## Before an Independent Hearings Panel at Waimakariri District Council

*under:* the Resource Management Act 1991  
*in the matter*  
*of:* Proposed Private Plan Change Request 31  
(PPCR31) to the Waimakariri District Plan

Summary Statement – Colin James Roxburgh  
Waimakariri District Council

Summary Statement on Water, Wastewater and Stormwater Relating to Private Plan  
Change Request PPCR31 – 535 Mill Road, Ohoka Plan Change Application

Figure 1: Schematic of stormwater basin proposal

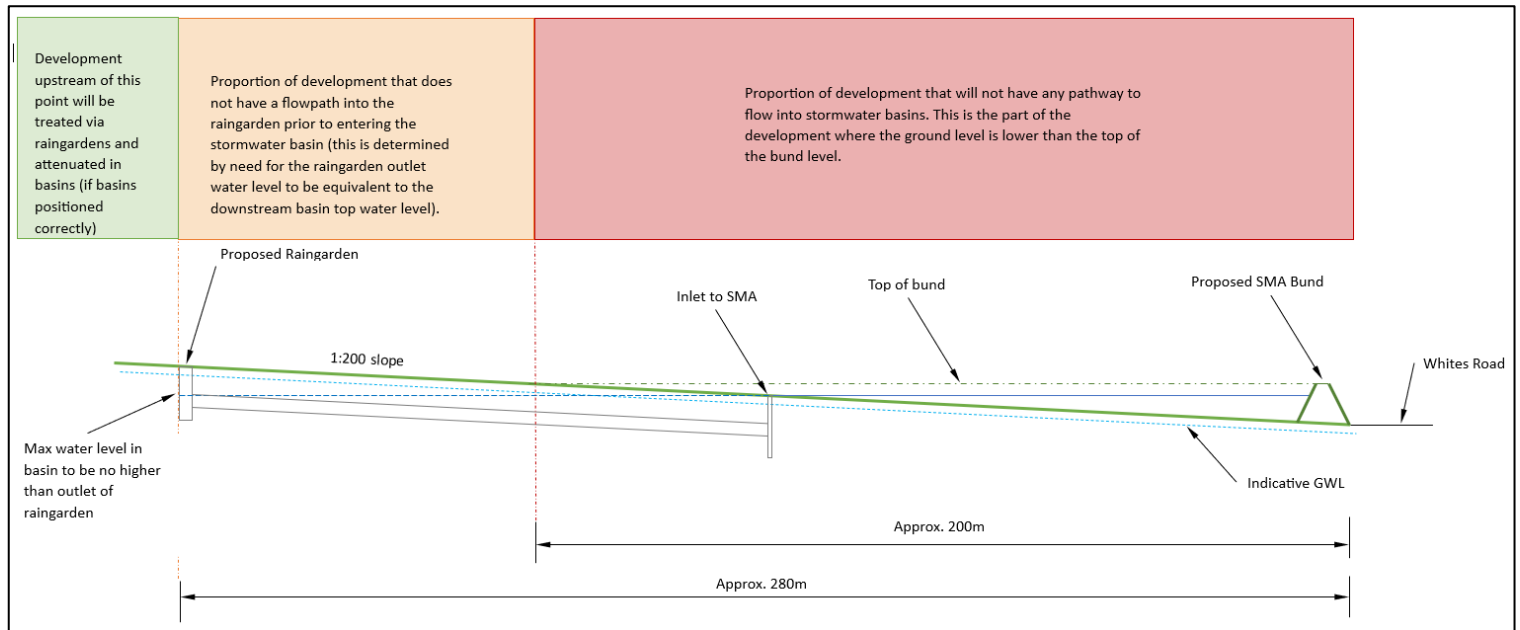
38. There is a more inherent challenge with the approach of constructing above ground basins (in order to avoid the water table) rather than the more conventional approach of construction basins below ground. With the runoff being first treated by below ground rain gardens, then attenuated in above ground basins, some areas of the development would not be able to drain into a basin and therefore would not be attenuated, requiring that some of the runoff be discharged directly into the receiving environment.

39. This is a problem that comes from the unconventional approach to get water to constructed storage basins entirely above ground, while still expecting water to flow by gravity from below ground infrastructure into the basins.

40. This was already a challenge when basins were to be constructed only 200mm below existing ground level, and is more of a challenge if they are to be constructed entirely above ground, and as such even greater areas of the development would have to discharge directly into the receiving environment without attenuation. As noted in the recent July 2023 flood events, the Ohoka area is already susceptible to flooding, and anything that presents a risk of making this worse should be avoided.

Figure 3: Overlay of unattenuated area over view of detention basin provided by applicant

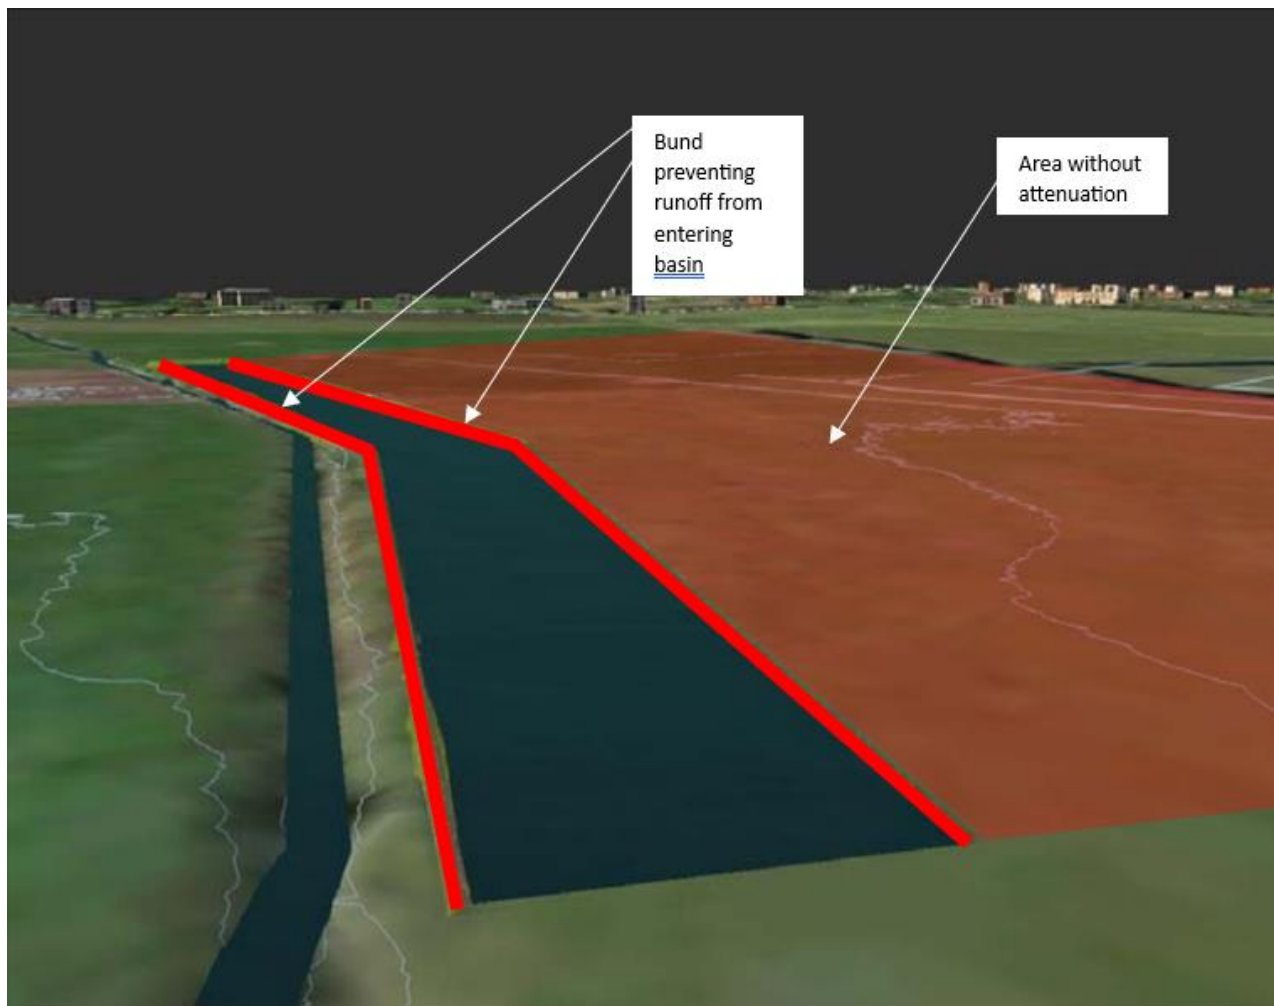
41. I have provided Attachment 1 to help illustrate what I have calculated to be the area of the development that will not be able to be attenuated, based on information provided by the applicant. This shows that an area extending approximately 280m upstream of Whites Road would not be able to be both treated by rain gardens and attenuated, and therefore would have to discharge directly into the downstream system. The risk with not attenuating the increased runoff caused by the development is that this could increase flows to the downstream system, and therefore could increase flooding.

43. In Mr. O'Neill's evidence, he refers to Attachment 2 for the detention pond locations, which was later corrected to be Attachment 3 of his updated evidence. It is noted that some of the basins do not appear to be positioned to minimise the amount of compensatory storage required, which could mean that there is an even greater proportion of the site where attenuation is not provided than I had calculated in Attachment 1. This is a concern because the more unattenuated flow from the development, the greater the risk of downstream impacts
